CITY OF PORTLAND, MAINE  
PLANNING BOARD

Project Name: Seaport Lofts (Bay House Phase II)  
Address: 101-121 Newbury St./40 Hancock St.  
Applicant: 113 Newbury Street, LLC

# PLANNING BOARD REPORT PORTLAND, MAINE

Seaport Lofts (Bay House Phase II)  
101-121 Newbury Street and 40 Hancock Street  
Level III Site Plan and Subdivision Review  
2013-179  
113 Newbury Street, LLC, Applicant

Figures 4, 5, 6, and 7: Revised elevations, showing changes in window and door design, Newbury Street canopy, and façade composition.

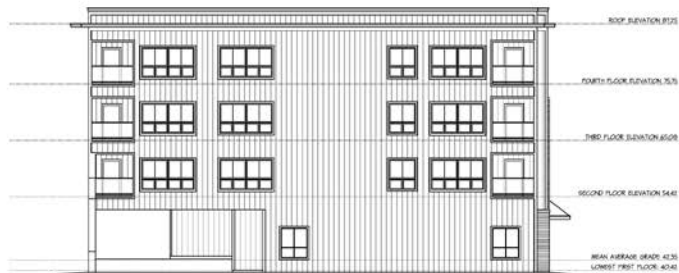
Responding to staff requests, the applicant has made some effort to enhance the building entrances. The door of the main, shared entry on Newbury Street has been pulled out to the face of the building. The architect has also altered the awning in this area to represent a more contemporary style. The details of the awning design remain to be resolved. In addition, a Hancock Street awning, while newly added, is shown in the original style. The city has asked the architect to revise the awning in this area to match that on the Newbury Street façade.

In response to repeated comments about the flatness of the building, the applicant has altered the composition of the Newbury street façade, alternating between brick and metal cladding on the third floor, to provide some vertical accentuation, visual interest, as well as definition for the main entrance. The applicant has also changed the material configuration on the west end and the posts at the building’s rear. Staff has requested that the architect add a soldier course at the top of the second floor in order to rationalize the change in composition there, where the townhouse units meet the upper story flats.

Window mullions were added, and the openings on the west elevation have been reconfigured slightly; they now match the scale of the window openings above. On the rear of the building, the applicant has reduced the size of the balconies and added windows.

Figure 5: Proposed Hancock Street elevation

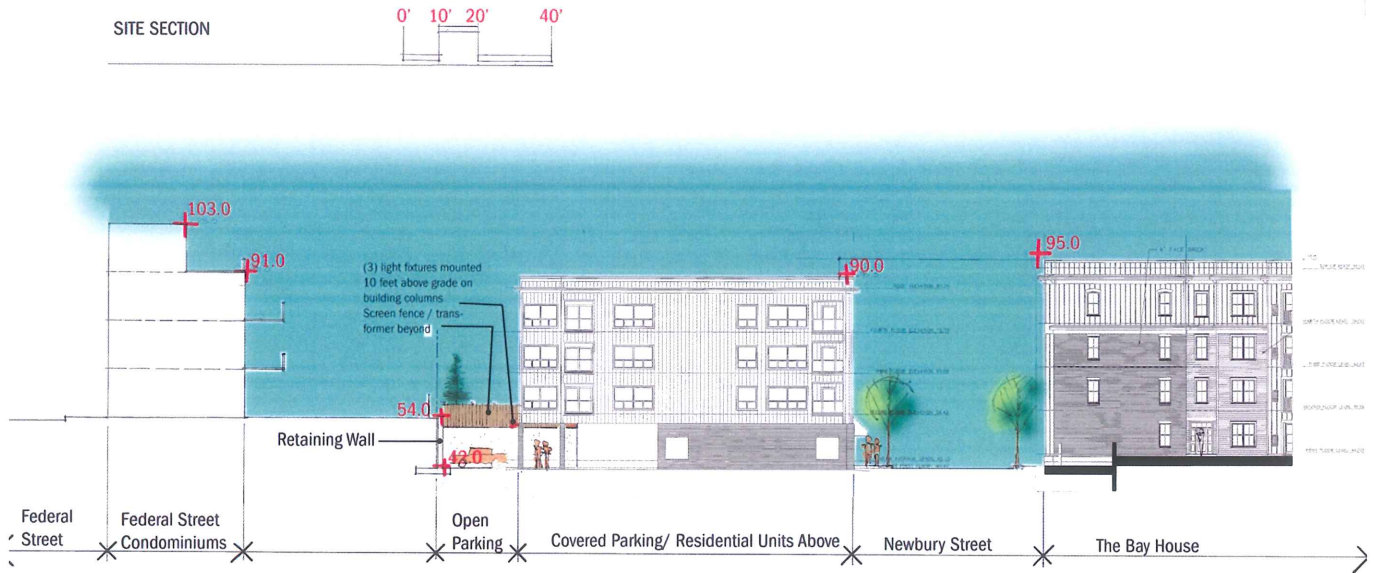
Figure 5 below shows the proposed Hancock Street grade elevations. Much of the shadow impact from the Seaport Lofts would fall on the northerly residential buildings, although this would be mitigated slightly by the elevation change toward Federal Street. There would be no shadow impacts to publicly accessible open spaces. Per the Technical Manual, a shadow study is not required for Level II or III developments that are less than 45 feet tall (*Section 11.3*). Though the height remains to be verified by the zoning administrator, it is the applicant’s intent that the building meet the zoning height limit.
